**AGENDA
TECHNICAL REVIEW COMMITTEE
REGULAR MEETING
AUGUST 27, 2020
9:00 AM
CITY HALL COMMISSION CHAMBERS
204 ASH STREET
FERNANDINA BEACH, FL 32034**

Re: Bistro 2020
14 N. 2nd Street
Fernandina Beach, FL 32034
Our File #15018

SMCC PARKING LOT- PHASE 2
FINAL ENGINEERING PLANS
COVER SHEET

SITE PLAN

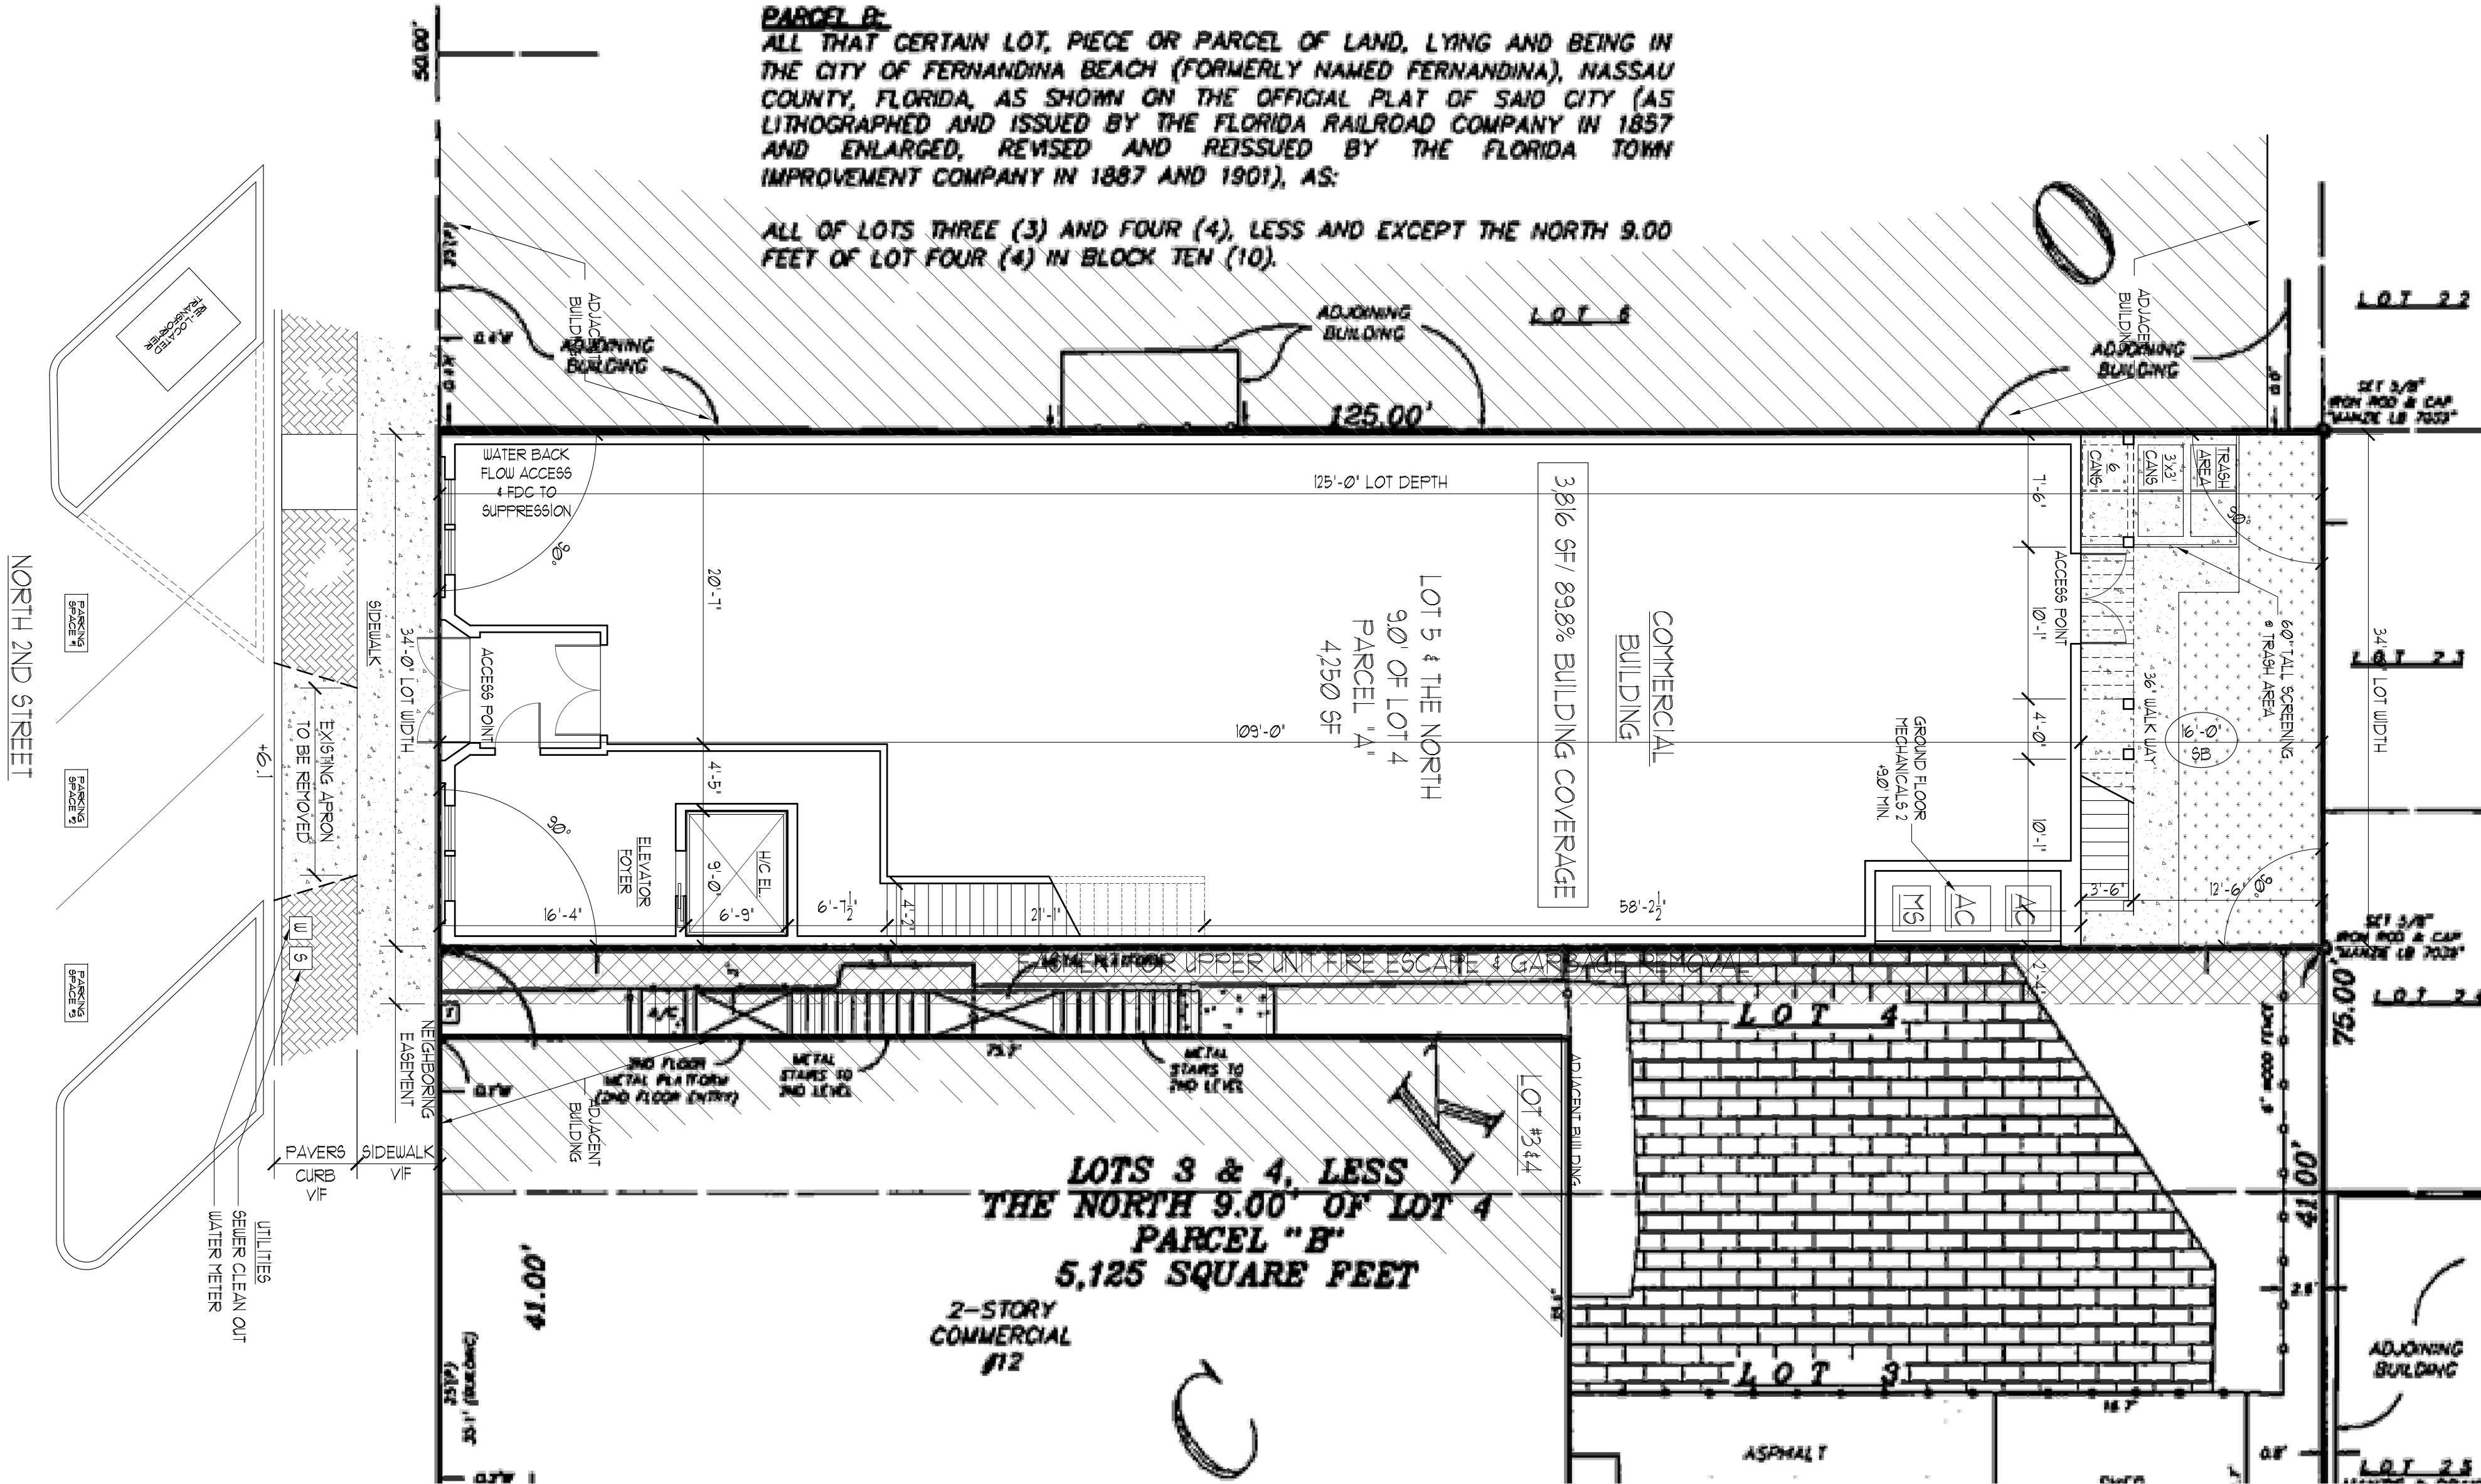
- Where the existing driveway connection is being removed, sidewalk must be stamped with hexagonal and stained brick patterns to match existing.
- Three shade trees are required for minimum planting. Where will these trees be located?
- Irrigation and landscape plan not provided. Rooftop planters are not practical and insufficient to meet minimum requirement.
- The summary block has discrepancies on FAR and “non-residential use.” The proposal does not have a residential component.

- Sheets S-1 and S-2 have been revised to show where the existing driveway connection is being removed. The new sidewalk will be stamped with hexagonal and stained brick patterns to match the existing sidewalk.
- The location of the 3 shade trees are shown on sheet S-2.
- Sheet S-2 provides the landscape and irrigation plan. A waiver is requested to allow for the rooftop planters to be considered acceptable landscaping.
- The summary block on sheet S-1 has been revised to remove the FAR discrepancies.

LANDSCAPING PLAN

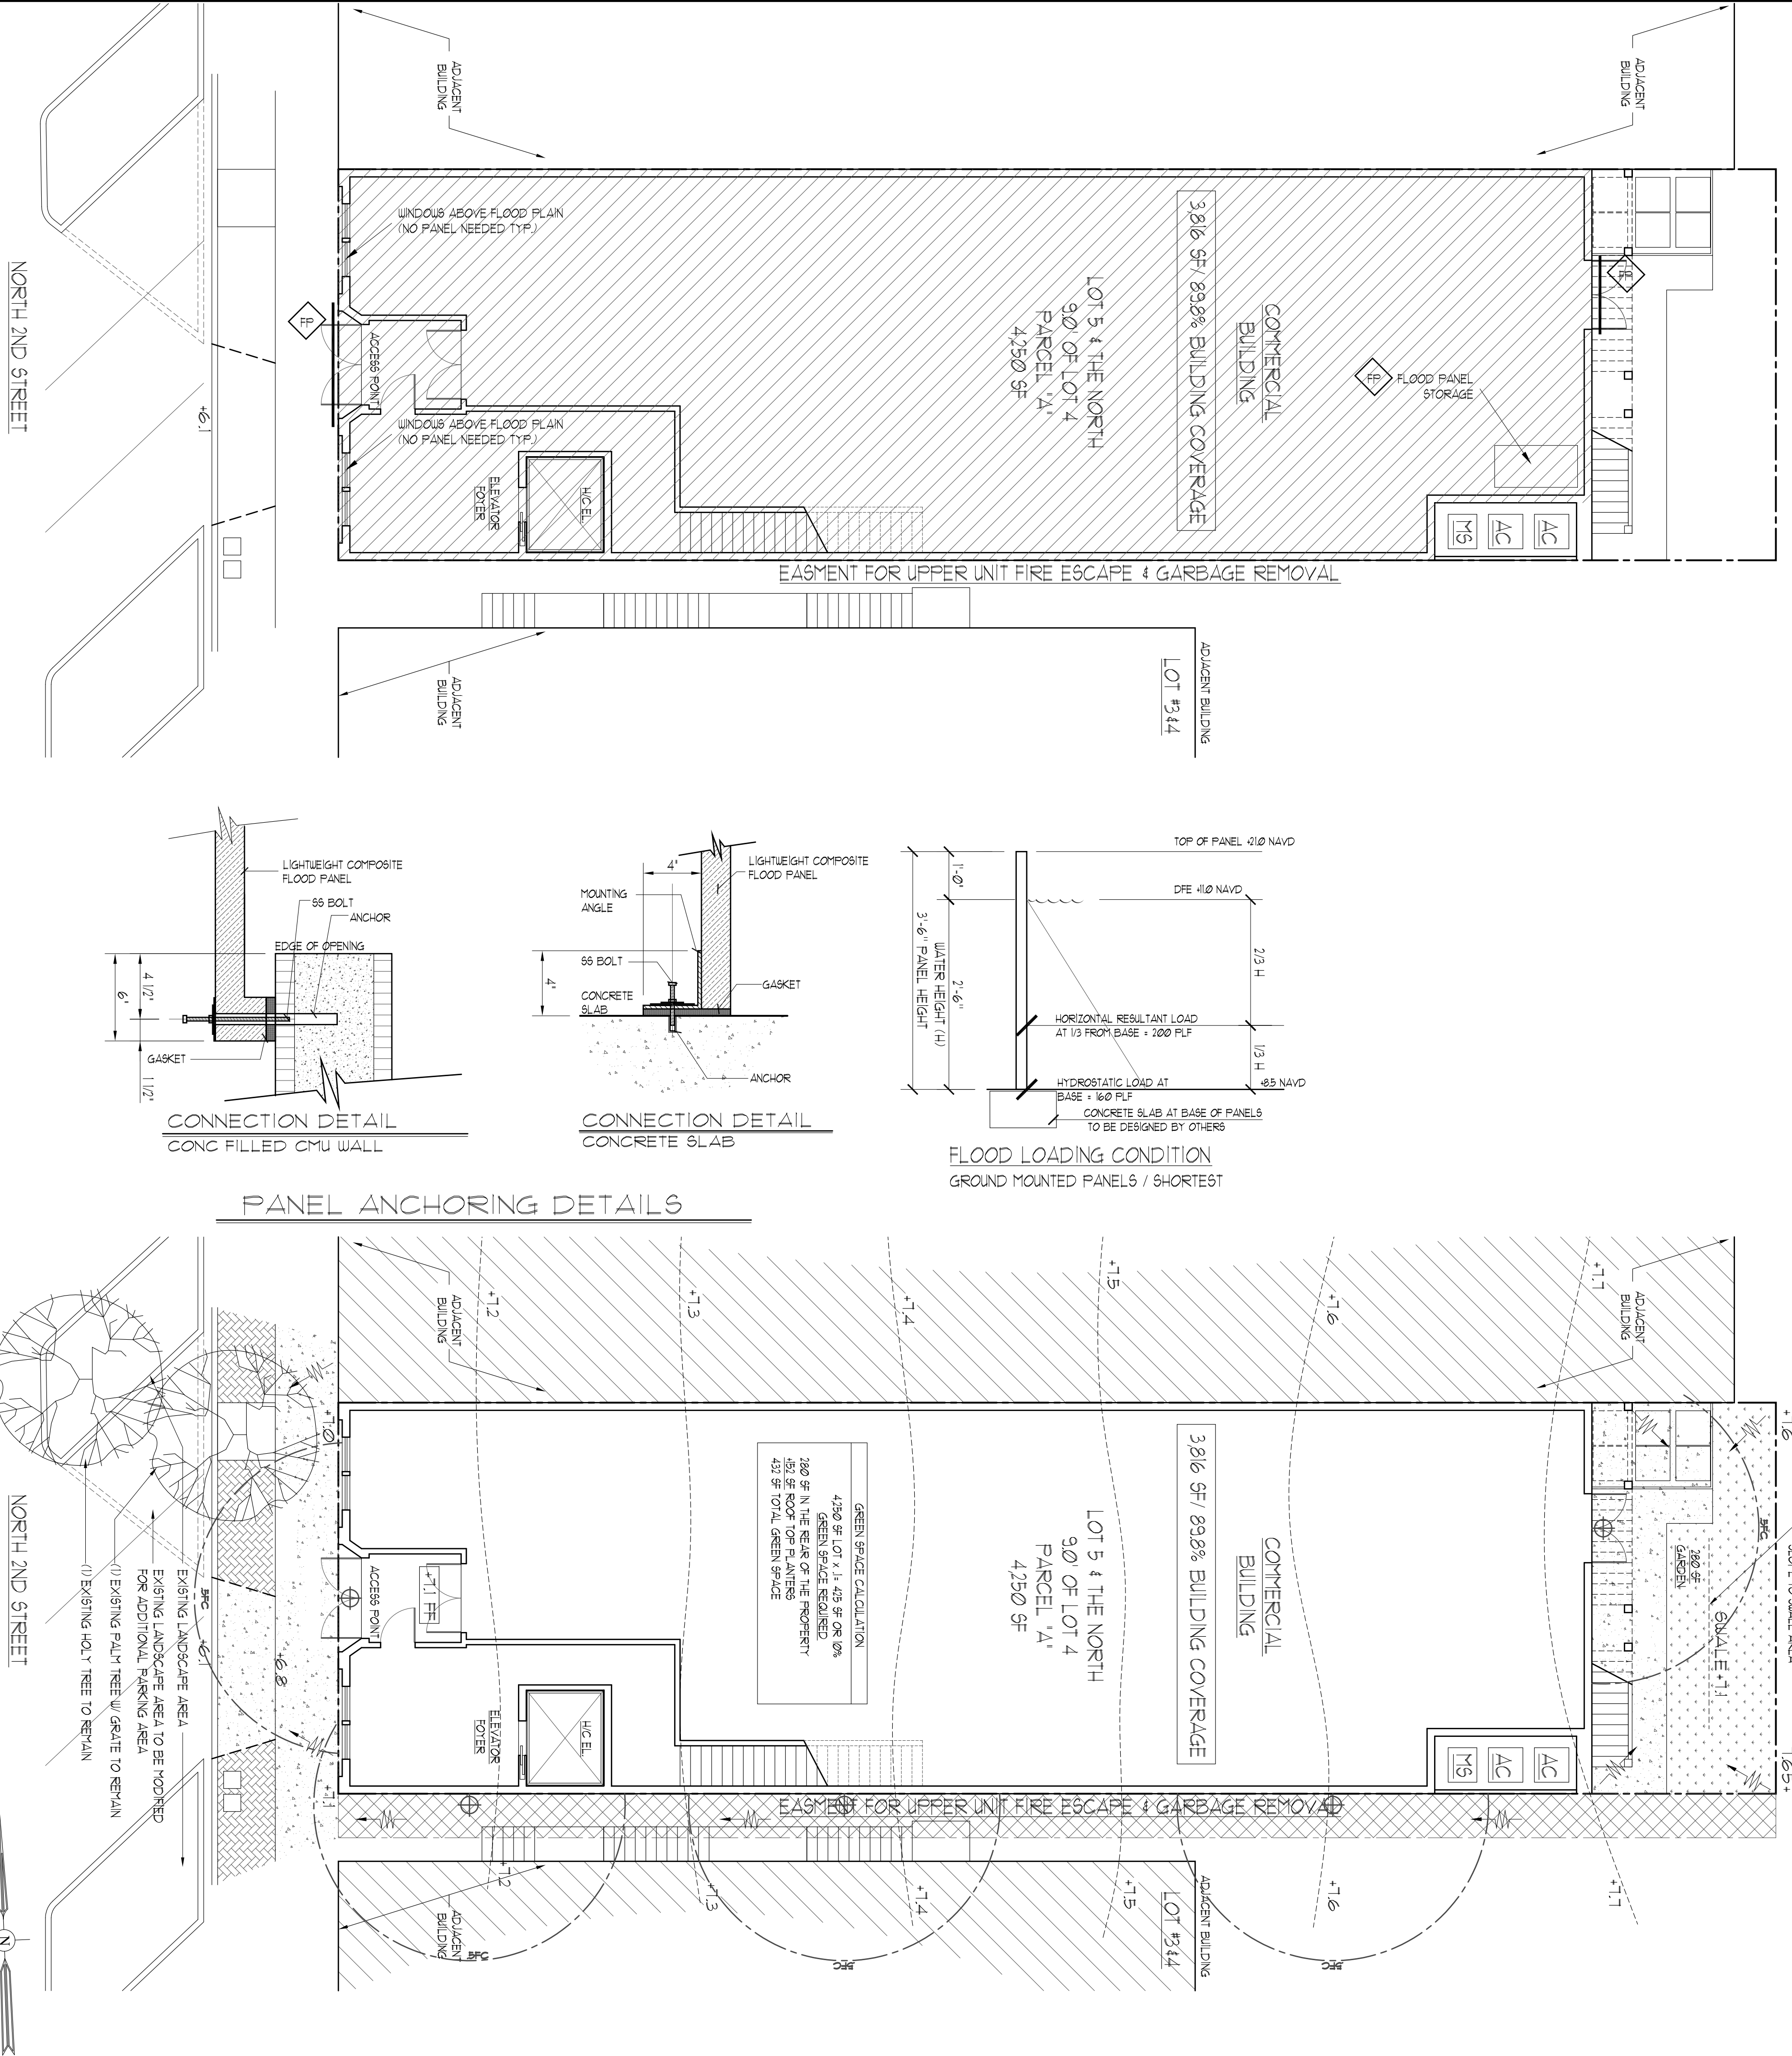
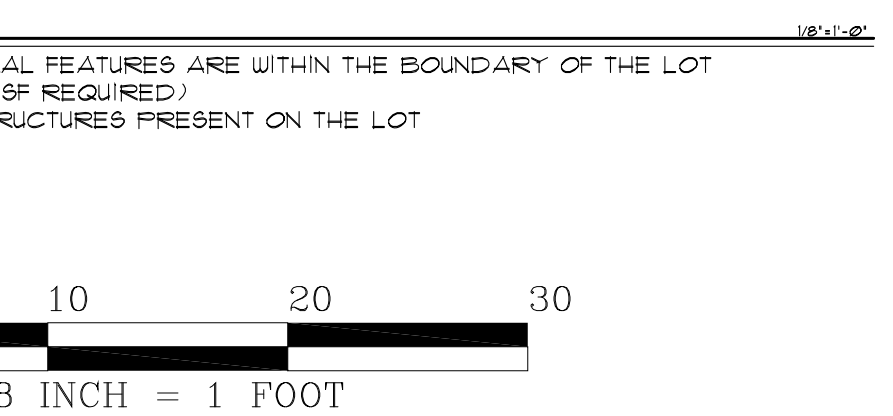
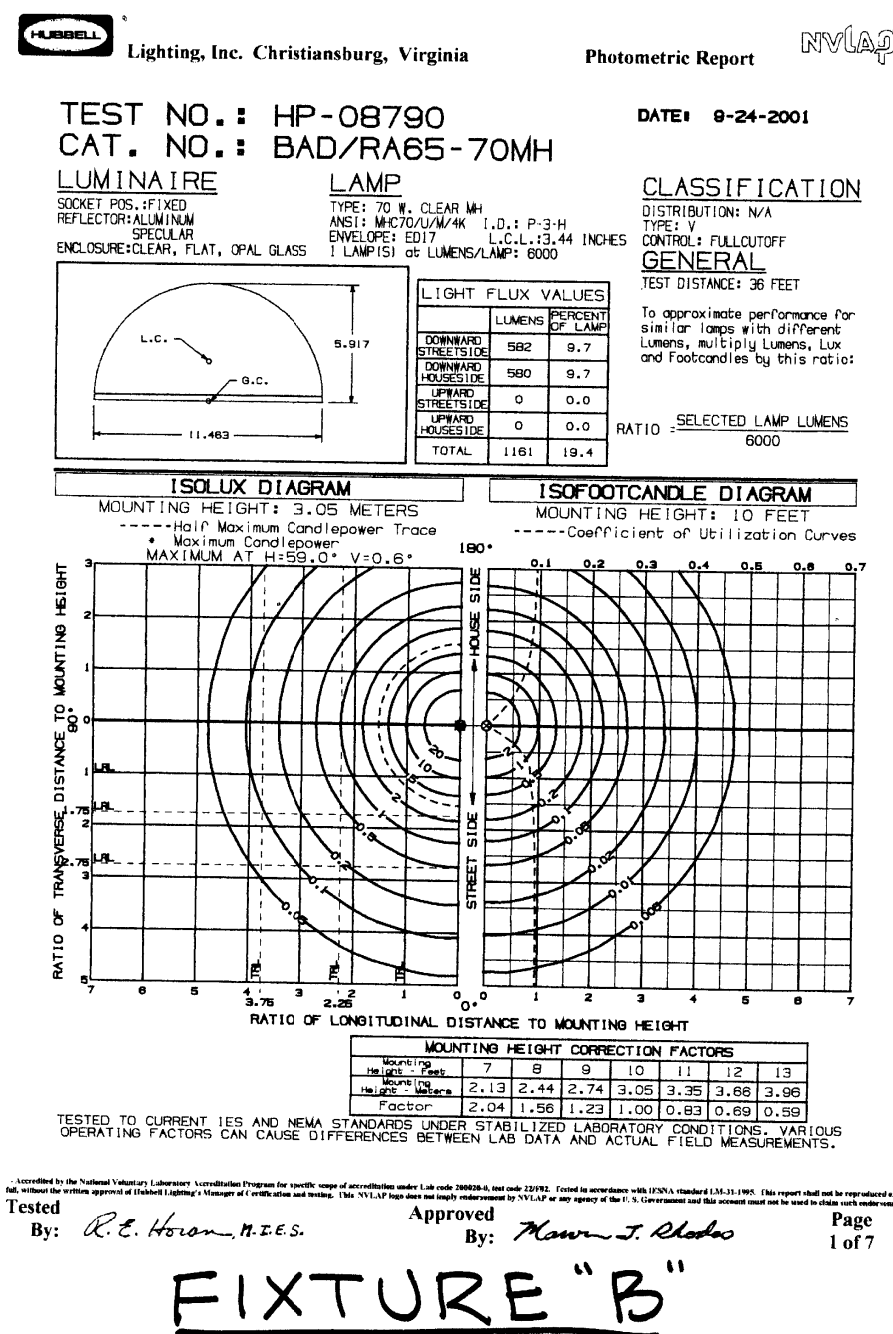
- Clarify if project will fall under SJRWMD or FDEP Environmental Resource Permit thresholds or provide the necessary permit.
- Sheet S-1 notes that impervious coverage may be 100% “where stormwater facilities are available and have sufficient capacity to accept runoff from the lot”. No calculations have been provided regarding runoff or sufficient capacity of the stormwater facilities. This needs to be clarified. This does not satisfy the requirements of LDC 3.05.03F.

- The proper fire rated ceiling/ floor are shown on sheets A-4 and A-5.
- The Florida codes used are noted on sheet S-2.
- The FEMA Flood Plan information has been added to sheet S-2. Sheet A-2 and A-3 shows the design factors in NAVD format.
- The missing gutter leader has been added to sheet A-2.
- As shown on sheet A-3 the HVAC system has been raised to +11.0".
- The Handicapped Accessible water fountain with height measurements has been added to sheet A-6.
- Sheet A-9 shows the secondary rainwater leader from the roof to grade. This has also been shown on the

1 DETAILED WALL SECTION

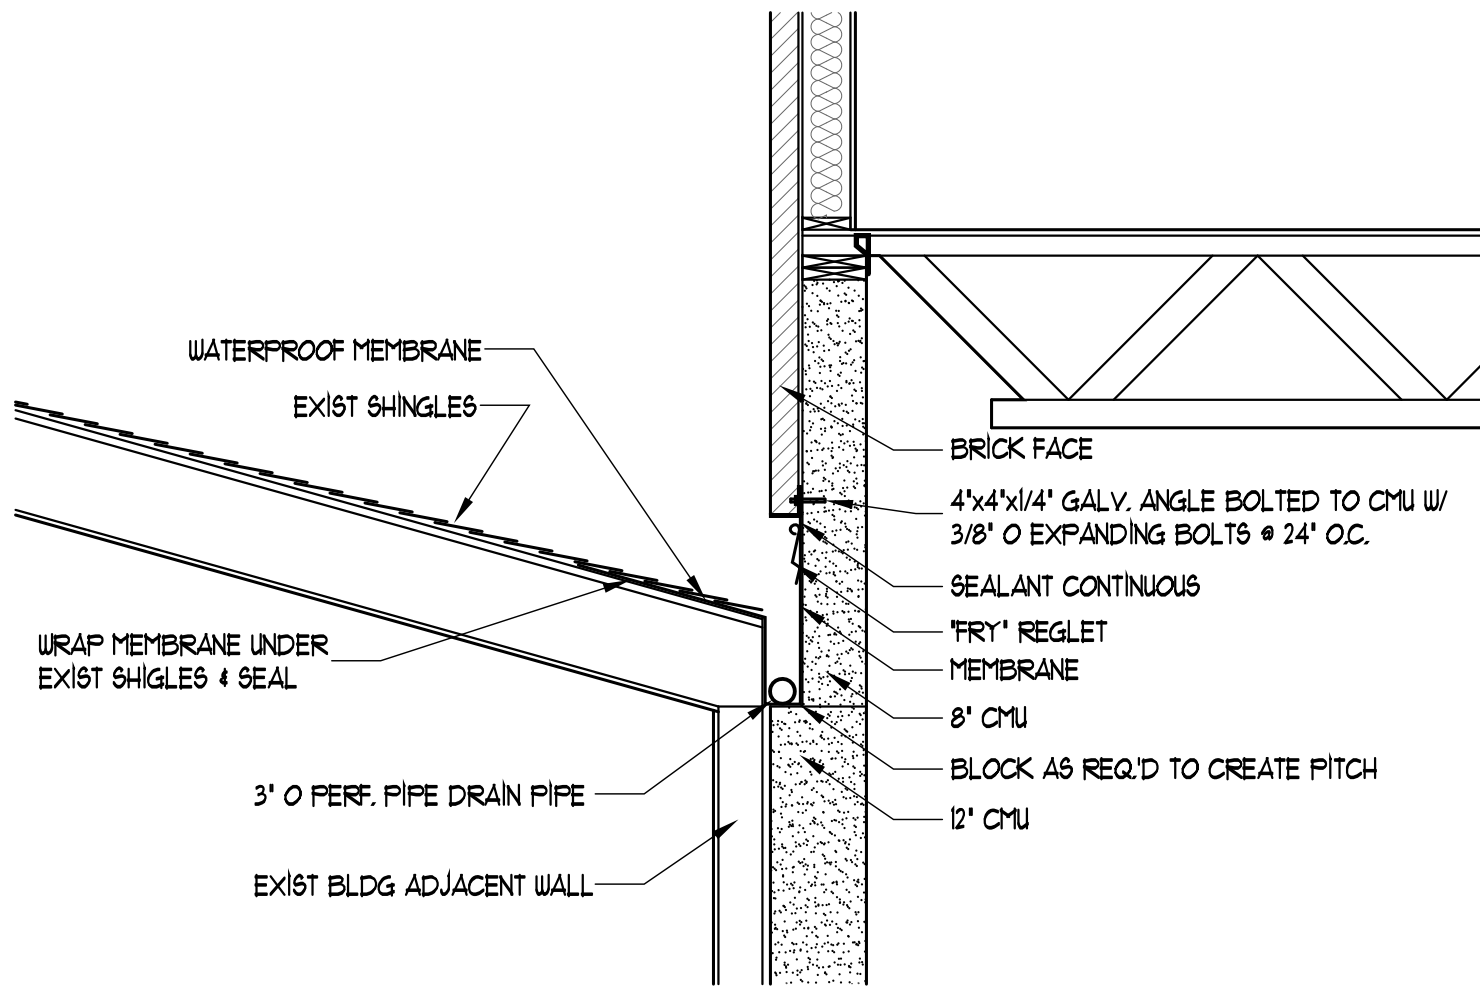
- Pg. EX- 1, please correct your code information in the general notes and specifications. The Wall Section and Gutter Details do they account for proper fire separation needs? How do you maintain this gutter system?

- The code information has been updated on sheet DTL-1. Also provided on sheet DTL-1 are the Gutter Details for gutter maintenance and Detailed Wall Section for depiction of fire rating.
